Southern Ute Indian Tribe Pipeline Abandonment Inspection Form

Inspector: John Doe, SUIT DOE Environmental Compliance Specialist jdoe@sudoe.us Office #: 970-563-5544, Cell #: 970-769-8795		Date Inspected: 12/03/2020, 12/04/2020		Operator: ACME Energy Co. Attendees: SUIT DOE, SUIT DNR	
Project Name: Taylor Mesa Abandonment Project					
Lease #(s): 15-452-854-V, 14-20-151-34A			Pipeline Invoice #(s): TL-152, TL-10A, TL-189		
ROW Name(s): Area 1 Trunk, ACME 1 Well Tie, ACME 2 Well Tie			Legal Description: See map attached to the approved NOI for each ROW listed.		
NOI #(s): 2020-0025, 2020-0026, 2020-0027

Narrative: The Southern Ute Indian Tribe (SUIT) Department of Energy (DOE) conducted a Pipeline Abandonment Inspection on the ACME Energy Company (ACME) "Taylor Mesa Abandonment" project area on 12/03/2021 & 12/04/2021. ACME will be abandoning the S portion of the pipeline system, largely in place. See corresponding approved NOI forms: 2020-0025, 2020-0026, 2020-0027 for additional details. Inspection Items #1, #3, & #8 were observed to be present/deficient during the inspection. See comments, photos, and maps below for additional details.

Issue Location #:
1 of 4

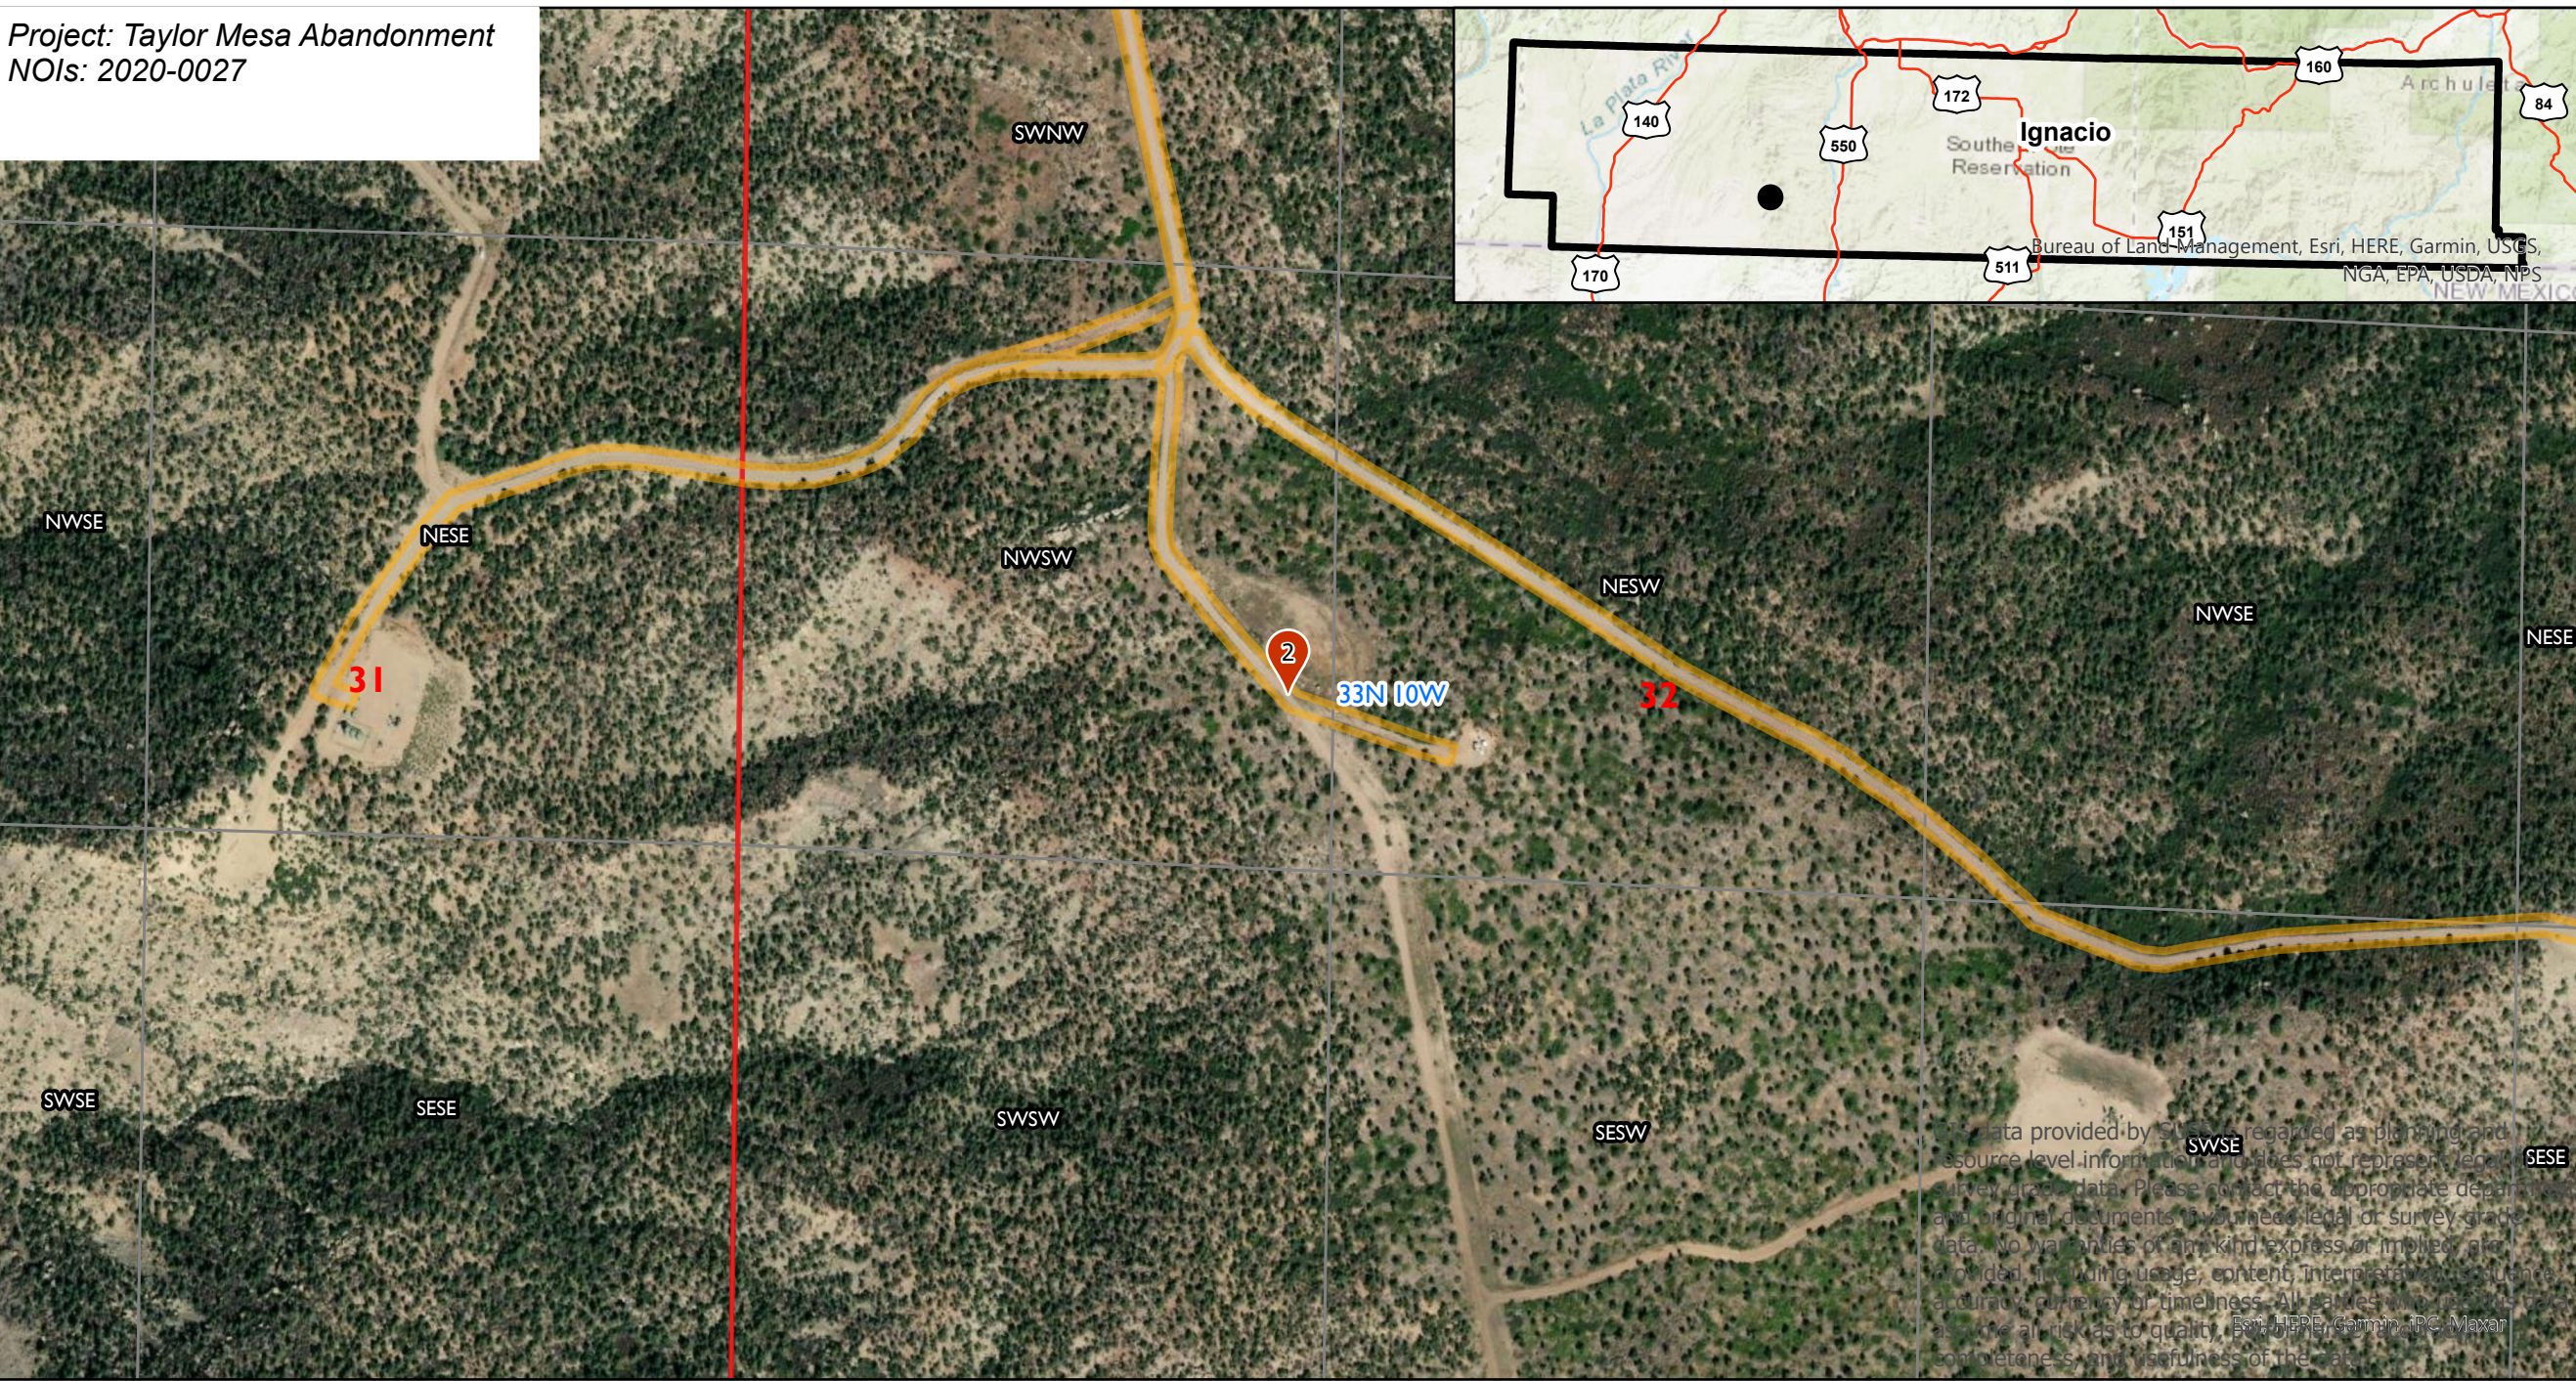
DOE Comments: One valve setting and metal barrier remains installed on the ROW at this location that will be fully removed. DOE requests that the disturbance resulting from removing this appurtenance/barrier be seeded and mulched with the attached seed mix. The seeded and mulched areas will be monitored for at least one year for the presence of Colorado list A and B noxious weeds. Please provide all applicable documentation for this work as detailed in the pipeline abandonment checklist form (appurtenance removal photos, cut/cap photos, etc.).

Issue Location #:
2 of 4

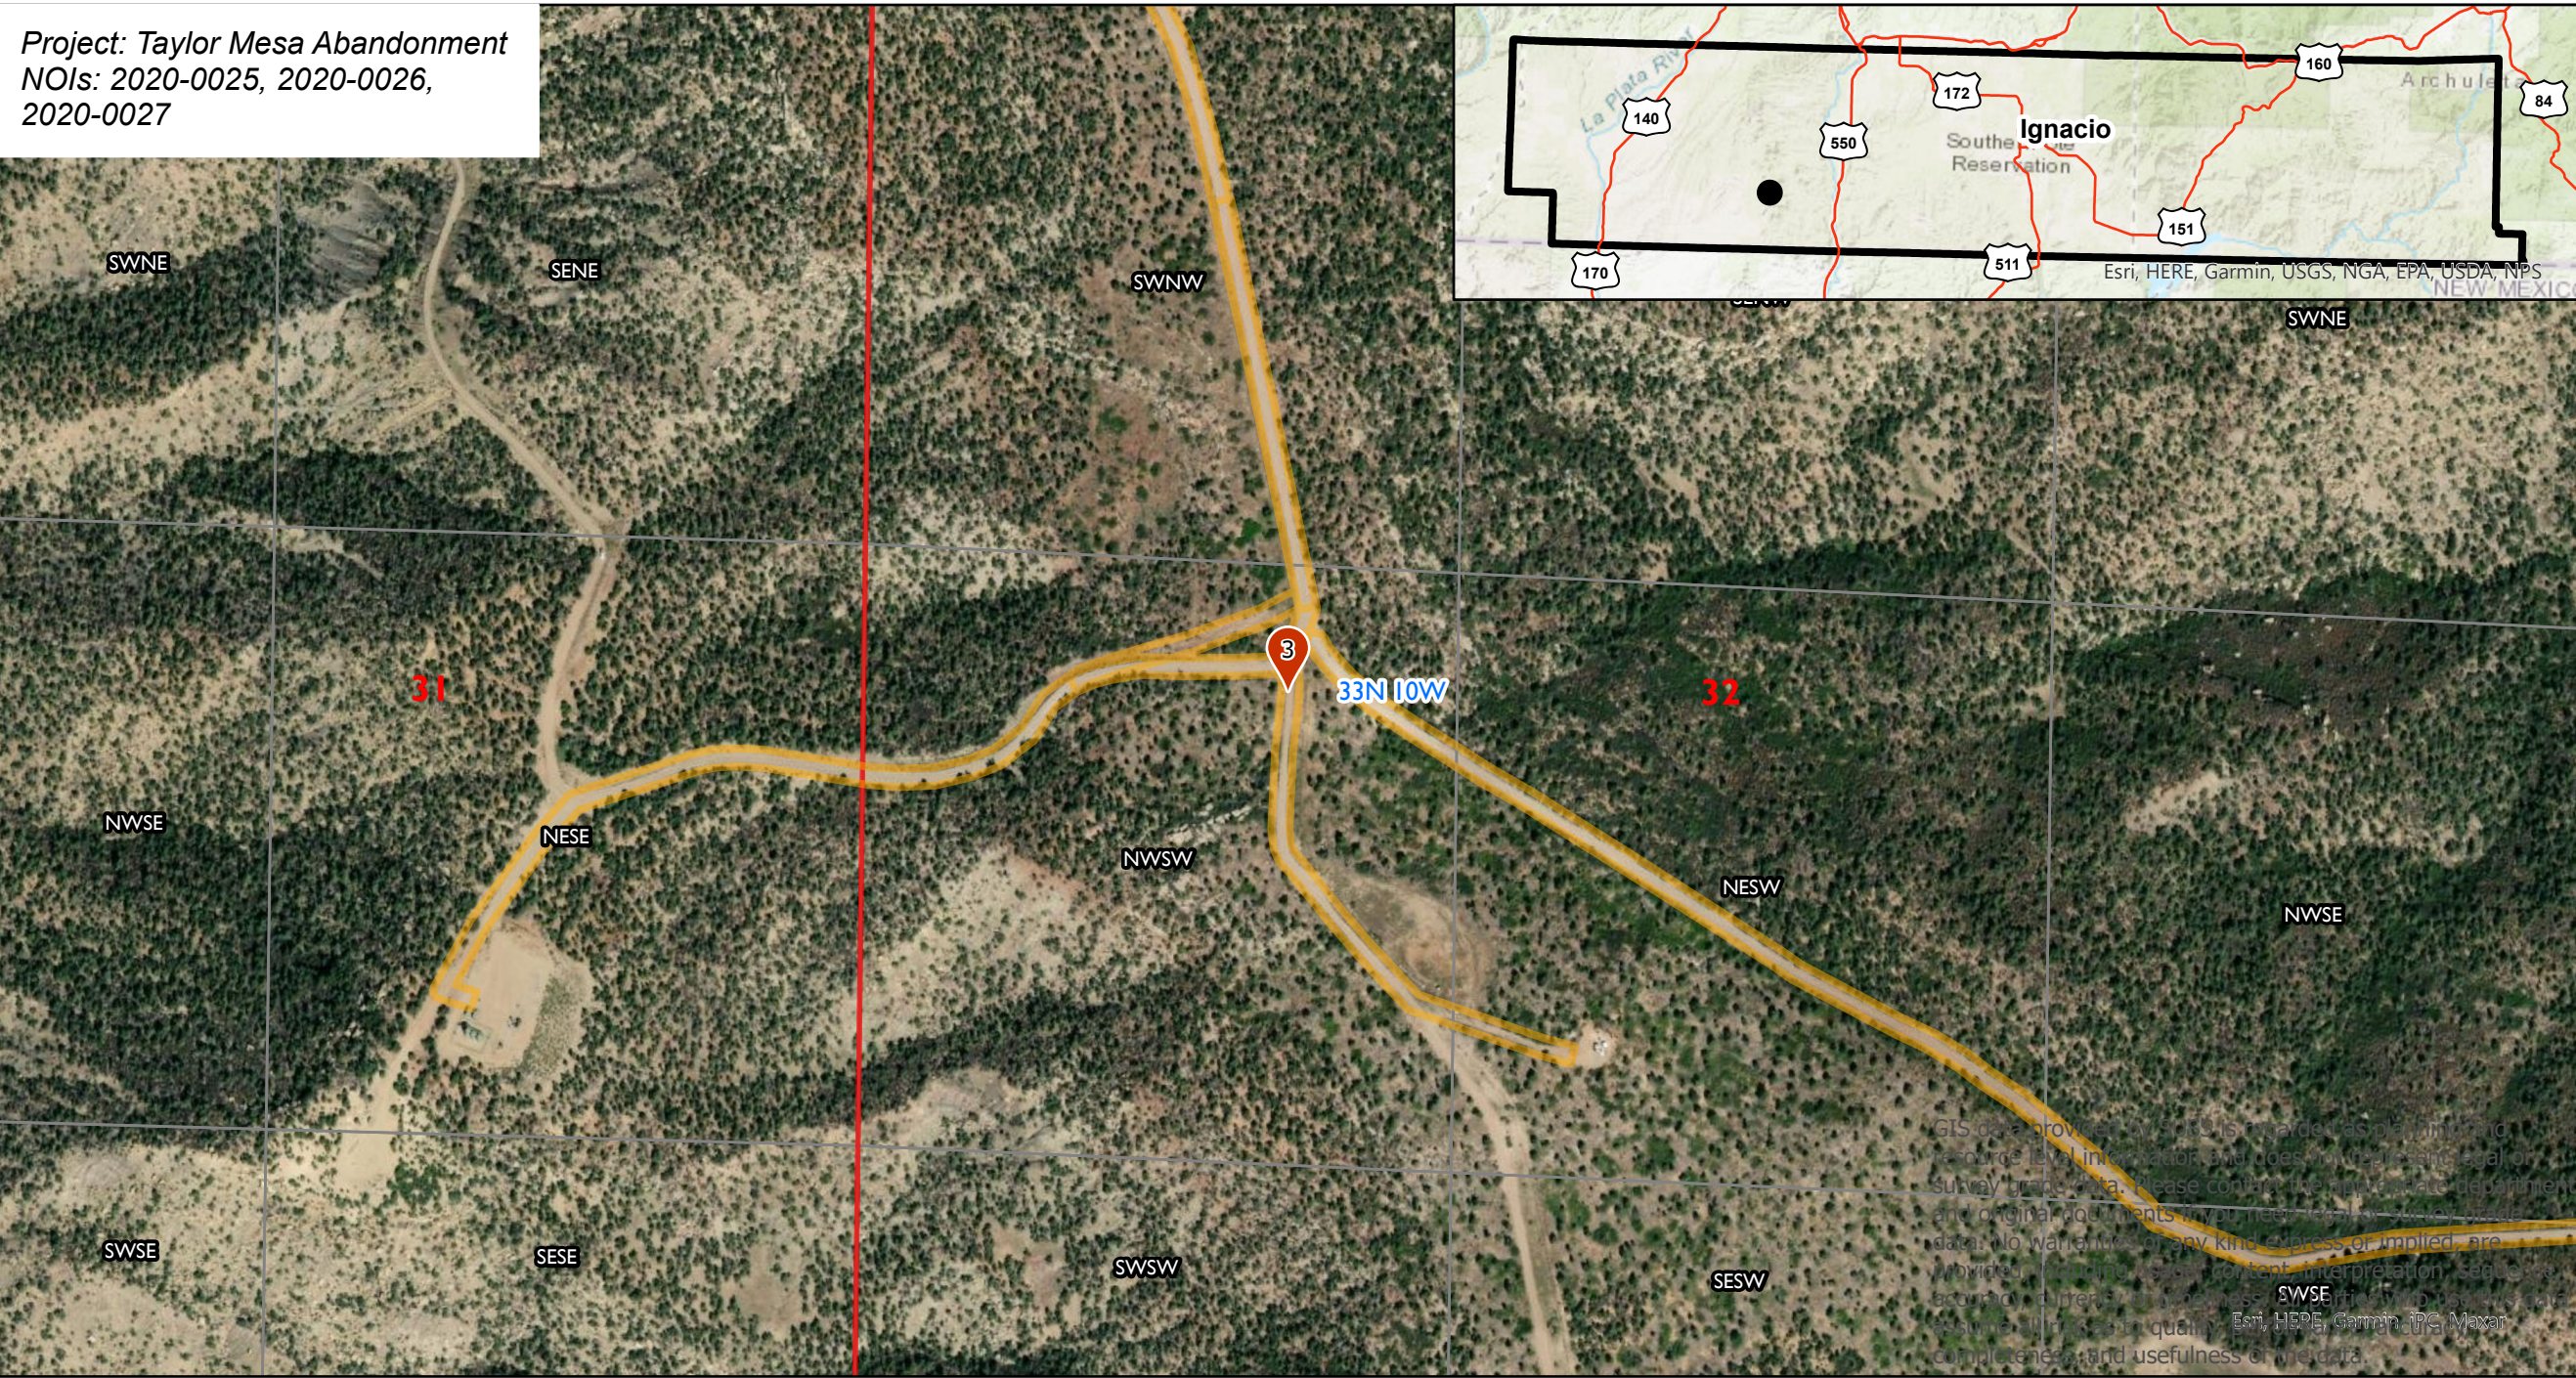
DOE Comments: One valve setting and metal barrier remains installed on the ROW at this location that will be fully removed. DOE requests that the disturbance resulting from removing this appurtenance/barrier be seeded and mulched with the attached seed mix. The seeded and mulched areas will be monitored for at least one year for the presence of Colorado list A and B noxious weeds. Please provide all applicable documentation for this work as detailed in the pipeline abandonment checklist form (appurtenance removal photos, cut/cap photos, etc.).

Issue Location #:
3 of 4

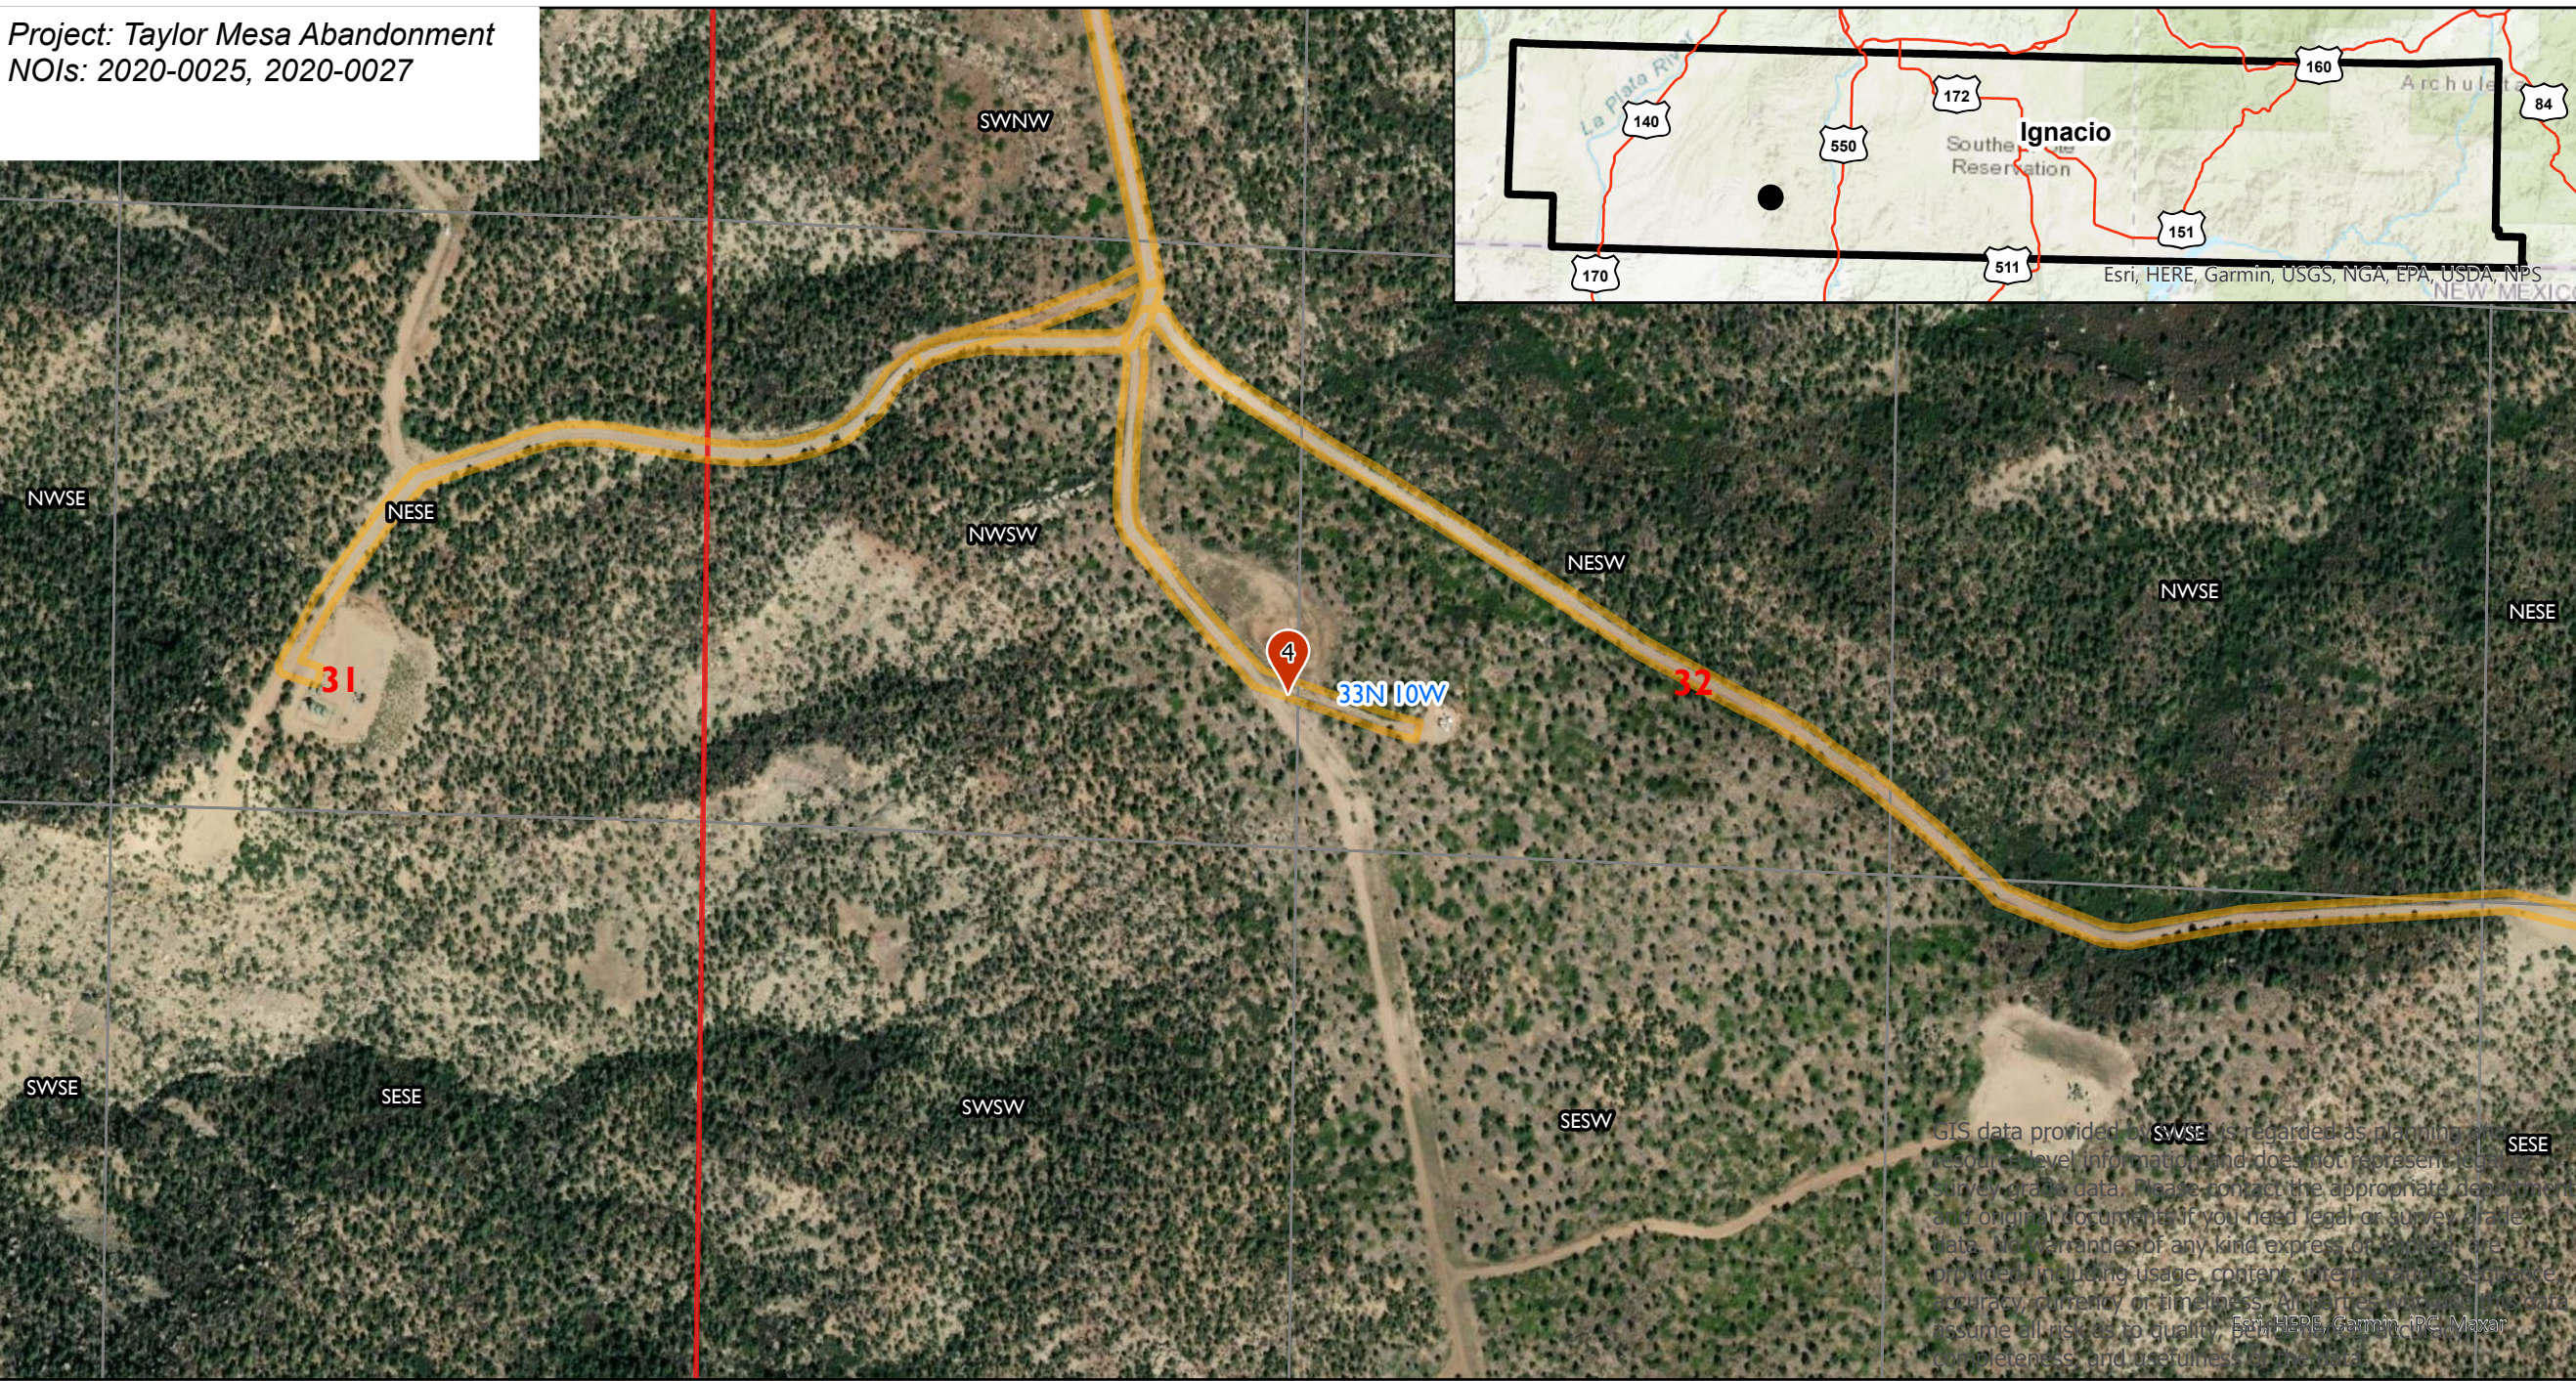
DOE Comments: Three (3) pipelines are to be abandoned in place across an ephemeral drainage at the location detailed below. DOE requests that Acme provide verification that each of the pipelines are at least 36 inches below ground surface at the lowest point in the drainage.
